DART SERVICE INSTRUCTION

TO AMEND INSTALLATION INSTRUCTIONS II145-6 Rev. A,
REF. TCCA STC: SH21-24
REF. EASA STC: 10077436

B	REVISED SECTION 2.3, ADDED SECTION 2.5 AND 2.6 BASED ON FEEDBACK FROM AIRBUS	CZ	22.02.18
A	NEW ISSUE	CZ	21.11.15
REV.	DESCRIPTION	BY	DATE
DESIGN	CZ	DART AEROSPACE LTD HAWKESBURY, ONTARIO, CANADA	
DRAWN	CZ		
CHECKED	JB	DRAWING NO.	REV. B
MFG. APPR.	N/A	DSI 9868	SHEET 1 OF 10
APPROVED	JB	TITLE	SCALE
DE APPR.	DS	INSTALL DEVIATIONS	NTS
DATE	22.02.18	COPYRIGHT © 2021 BY DART AEROSPACE LTD. THIS DOCUMENT IS PRIVATE AND CONFIDENTIAL AND IS SUPPLIED ON THE EXPRESS CONDITION THAT IT IS NOT TO BE USED FOR ANY PURPOSE OR COPIED OR COMMUNICATED TO ANY OTHER PERSON WITHOUT WRITTEN PERMISSION FROM DART AEROSPACE LTD.

FIGURE 1: RIVET REPLACEMENT LOCATION

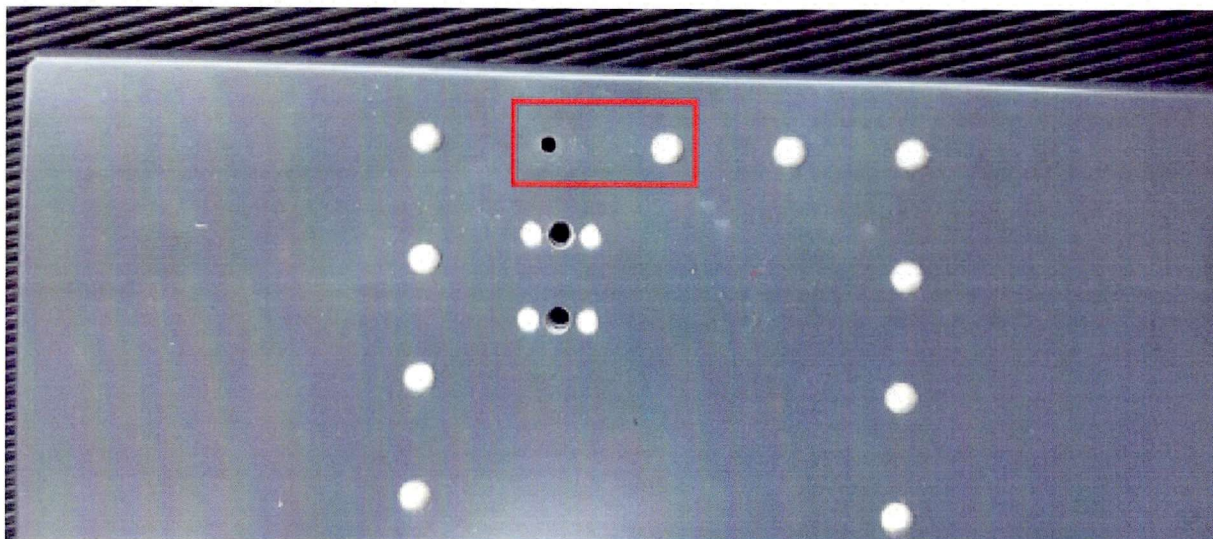
1. The pull handle lever, P/N 614.6202, cannot be installed as intended due to incompatibility with the current rivets used for doubler installation.
2. The instructions for removing the pin on the OEM fixed provisions prior to installing the DART removable provisions have been omitted.
3. The instructions for the placement of the Float Reservoir has been dimensioned incorrectly.
4. Fixed provisions were included on the removable provisions kit instead of the fixed provisions kit. Thus the parts list has been revised for the assemblies P/N 654.6703 and P/N 654.6704.
5. The instructions for the installation of the liferaft reservoir are unclear.
6. The locations for installing Click Bonds to secure the pull cables need to be more clearly defined.

1. Dimple the aluminum panel in the required rivet locations as shown in Figure 1 of this DSI in accordance with the Aircraft Maintenance Manual.
2. Replace rivet F/N 89, MS20470AD3-3, with countersunk rivet, DIN65399-3205BF.

FIGURE 2: OEM LOWER BRACKET PIN

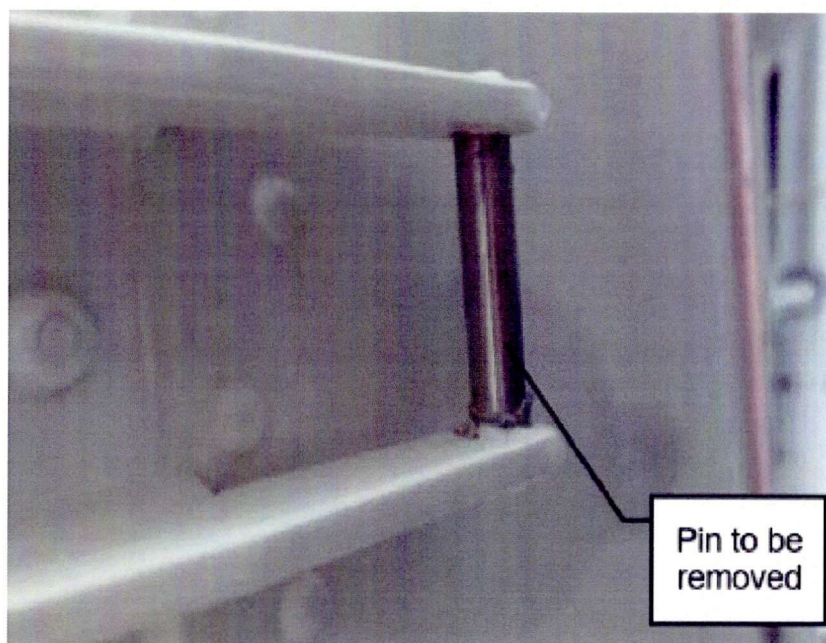
1. Remove the pressed pin, located on the OEM lower bracket, shown in Figure 2 of this DSI.
2. When installing the DART reservoir bracket, P/N 651.4010, on the OEM fixed provisions, use the alternate hardware listed in Table 4 on page 14 of II145-6 Rev. A.
3. The bushings (P/N 654.9810) internal diameter can be increased by up to 0.03" (.75 mm) to allow for proper fitment of the DART removable hardware onto the OEM fixed provisions.
4. Complete the installation of the DART brackets and reservoir per Section 2.3 of II145-6 Rev. A.

FIGURE 3: FLOAT RESERVOIR ALIGNMENT (APPROX. DIM.), RH HC VIEW

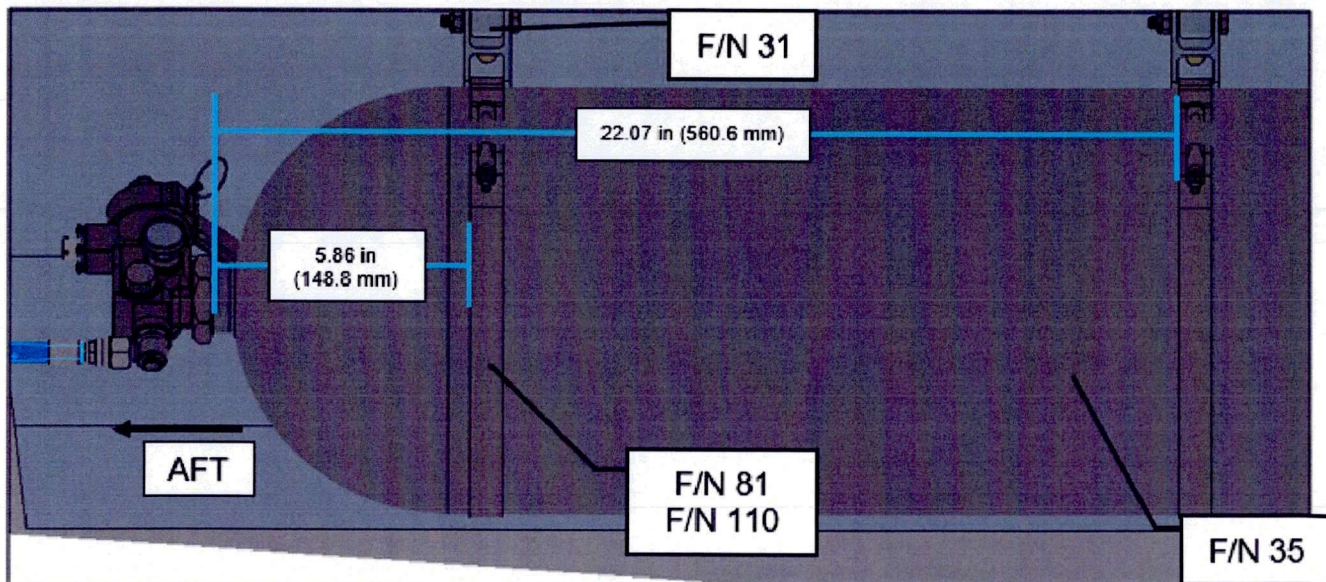
1. Reference Figure 3 of this DSI for the correct alignment of the Float Reservoir.
2. It is acceptable to shift the Float Reservoir aft by up to 2.90" (73.7 mm) to avoid interference with the DME antenna. If the bottle is shifted, the installer must confirm that the cable installation conforms to the NOTE on the bottom of page 50 of II145-6 Rev. A as well as the pull force requirements per Section 8.0 of II145-6 Rev. A.

NOTE: The float reservoir may be shifted by up to 2.90" (73.7 mm) aft of the dimensions shown in this figure to avoid interference with the DME antenna

FIGURE 4: LIFERAFT RESERVOIR CLAMP ALIGNMENT

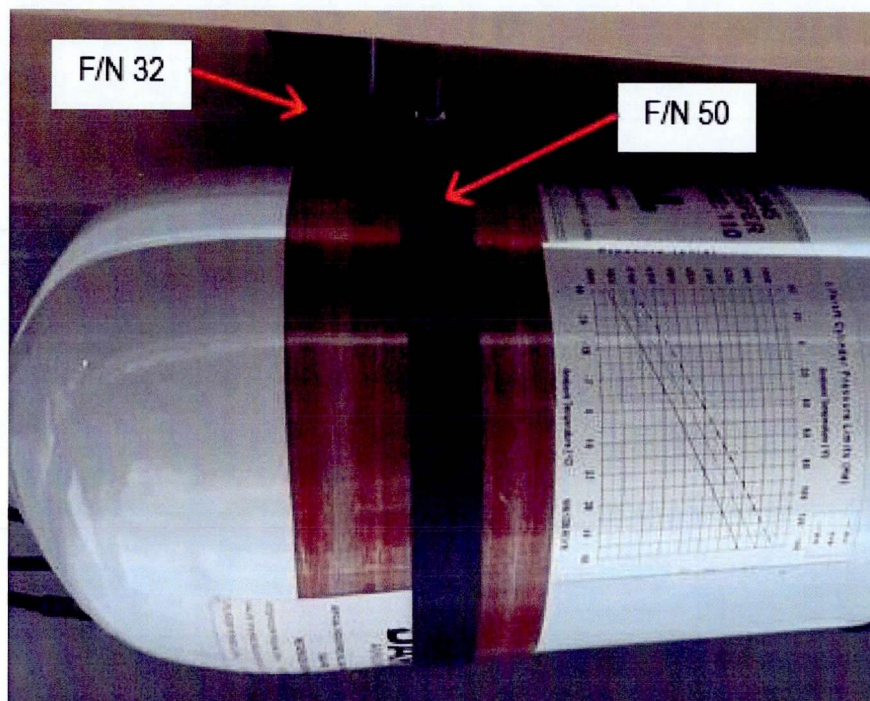
1. It is acceptable to install the clamp assemblies (F/N 50) such that the bolts are internal to the bracket assemblies (F/N 32) to prevent interference with passenger entry. Reference Figure 4 of this DSI for optional clamp orientation.
2. Reference Figure 5 for correct alignment of the Liferaft Reservoir. It is acceptable to shift the bottle aft by 1.0" (25.4 mm) while ensuring that the valve assembly clears the existing drain. If the bottle is shifted, the installer must confirm that the cable installation conforms to the NOTE on the bottom of page 57 of II145-6 Rev. A as well as the pull force requirements per Section 10.2 of II145-6 Rev. A.
3. It is acceptable to use either two washers or one washer (F/N 54) per bolt (F/N 56) to install the multi-cable box (F/N 60) to the cable box mount assembly (F/N 33) per Figure 15 of II145-6 Rev. A.

FIGURE 6: CLICK BOND LOCATION (APPROX. DIM.)

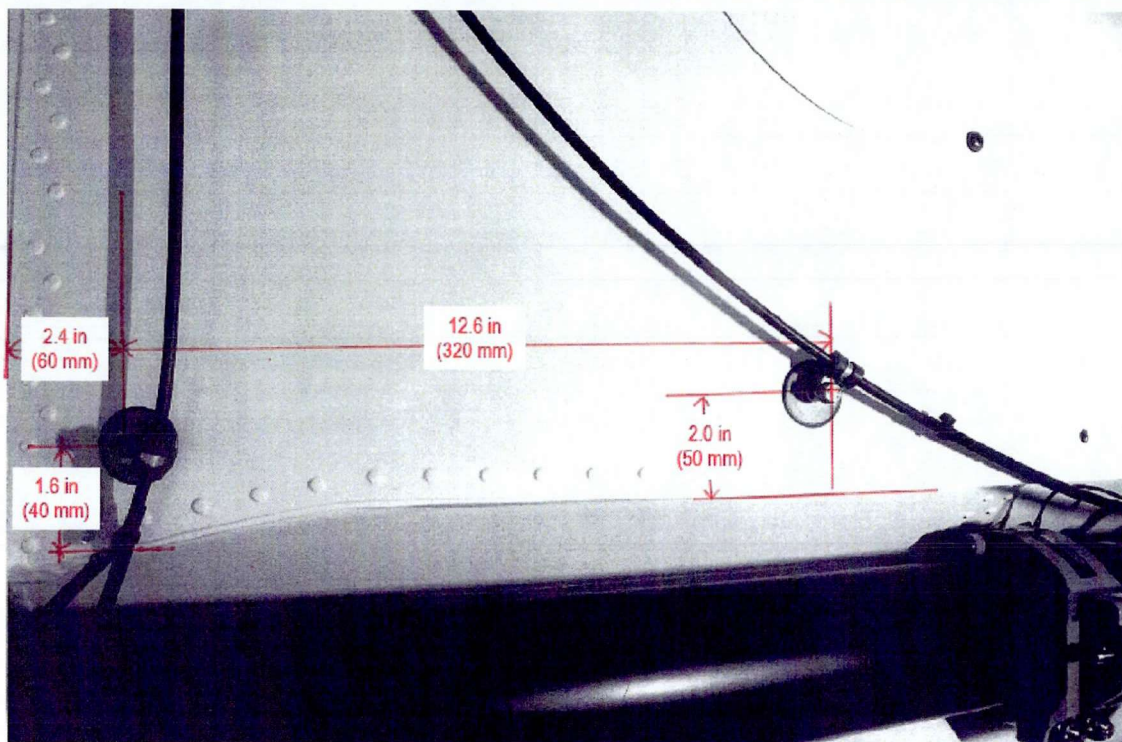
1. Rubber material may be used between the pull cables and Tywraps to allow for minimal cable movement and reduce chafing on the pull cables.
2. Reference Figure 6 - Figure 11 of this DSI for acceptable Click Bond (F/N 37) locations. A tolerance of 2.0" (50 mm) is acceptable on all dimensions. Additional Click Bonds may be required to remove any slack that may cause contact with the aircraft or other surrounding features.
3. The installer must confirm that the cable installation conforms to the NOTE on the bottom of page 50/57 of II145-6 Rev. A as well as the pull force requirements per Section 8.0 and Section 10.2 of II145-6 Rev. A.
